Response to Referee #2

This paper gives a very good account of the details of a camera suitable for sky imaging and would be a useful addition to the literature.

Figure 1 A comparison of the red-blue ratio between the (a-i) USI and the (b-i) TSI. The magnitude of the gradient is given in (ii) and the phase in (iii). The tiling effects of jpg compression can clearly be seen in all three TSI images.

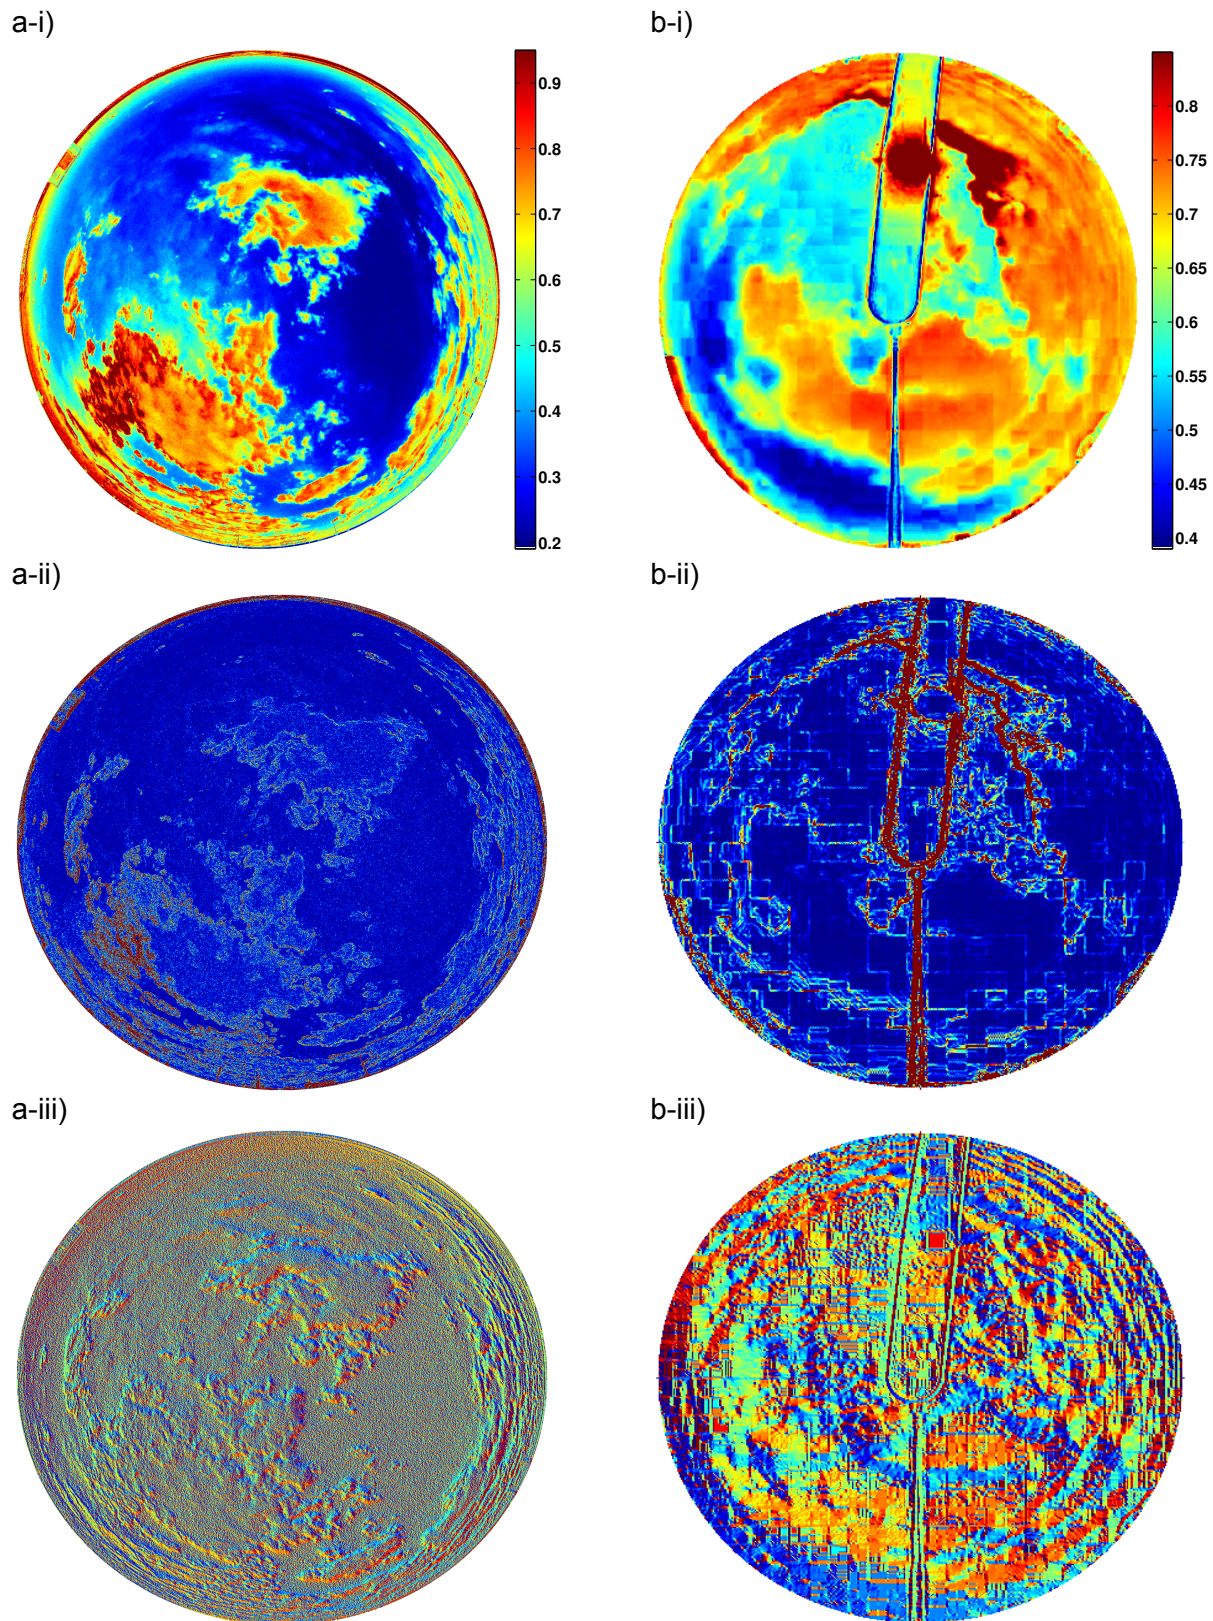
The spectral content of TSI images is impacted by the jpeg compression used for storing the images. This makes the use of the red-blue ratio for cloud detection more prone to errors. Figure 1 shows the red-blue ratio (RBR) along with the RBR gradient magnitude and phase (the x and y gradients were computed with a 5 point stencil, with their sum in quadrature being the magnitude and the arctangent of their ratio being the phase).

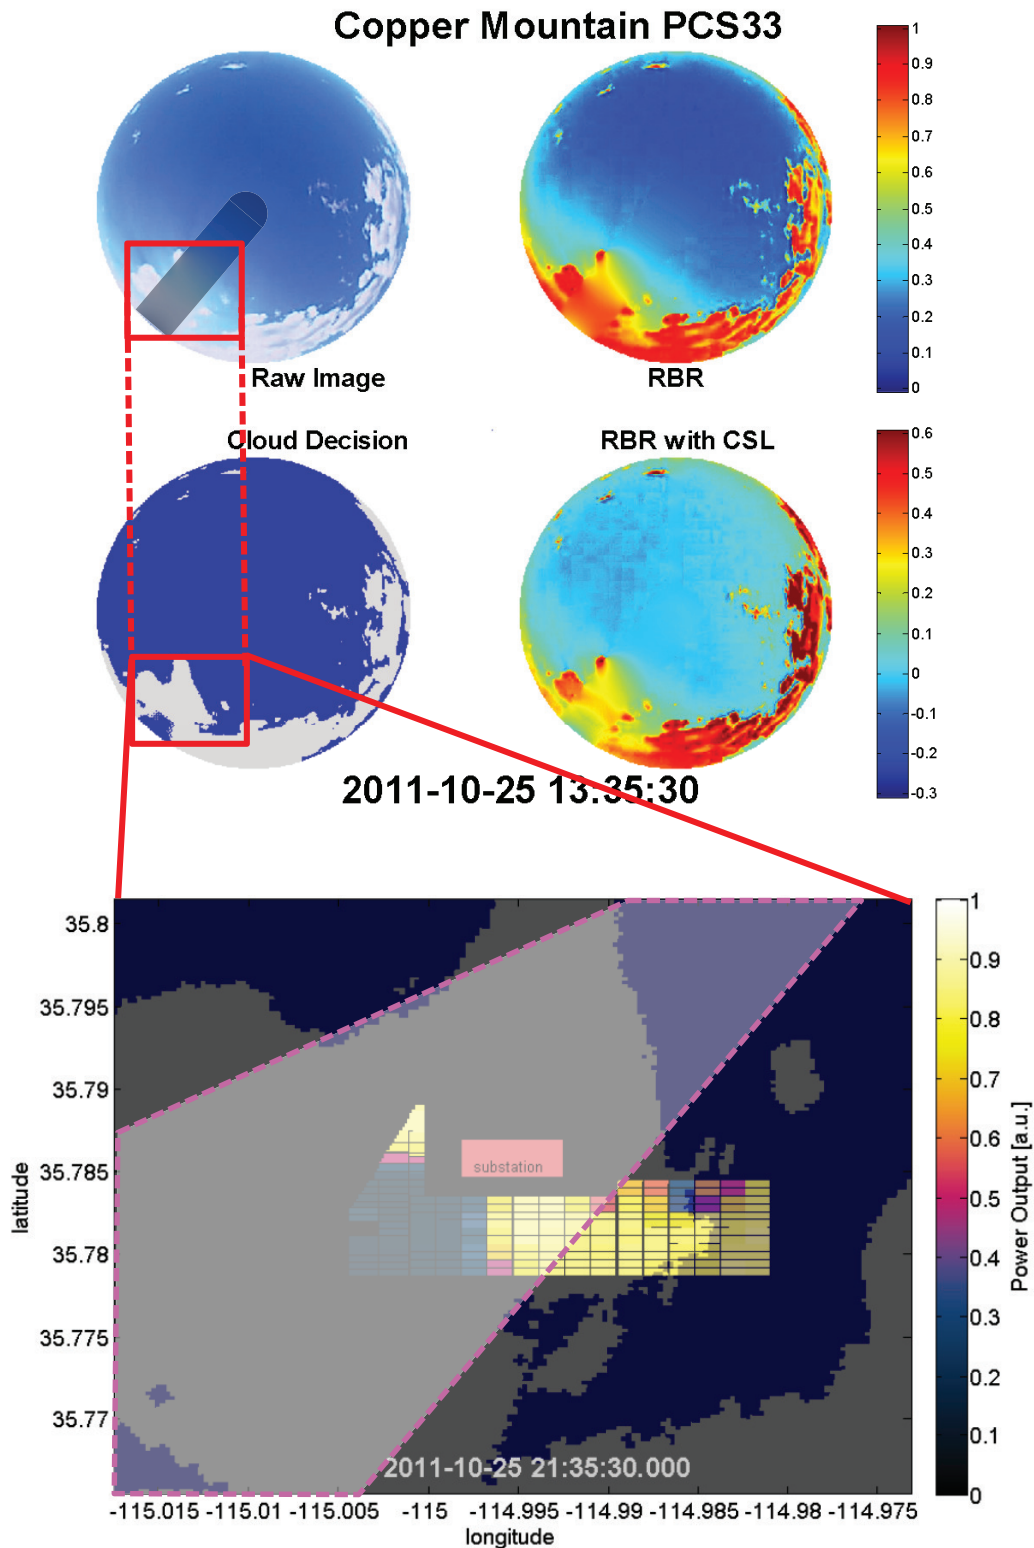
The shadowband on the TSI was one of our largest problems in solar power forecasting. The impact on cloud observation and its use for subsequent deterministic forecasting is shown in Figure 2. While the missing data due to the shadowband is interpolated, the forecast resulting from this missing data is not valid. Regions directly near the shadowband have reduced contrast and increased brightness, making cloud detection in the vicinity of the shadowband less accurate. The ray tracing of the cloud obstruction is shown in the bottom portion of Figure 2, where it can be seen that the missing data due to the shadowband covers about half of the plant. Additionally, the regions of poor contrast and increased brightness near the shadowband can be identified in the shadowmap by inspection, increasing the portion of the plant covered by no or poor observational data. The cloud height here is 3,000 meters. The projected area of coverage scales with the square of the cloud height, thus at larger heights, the shadowband covers more of the plant.
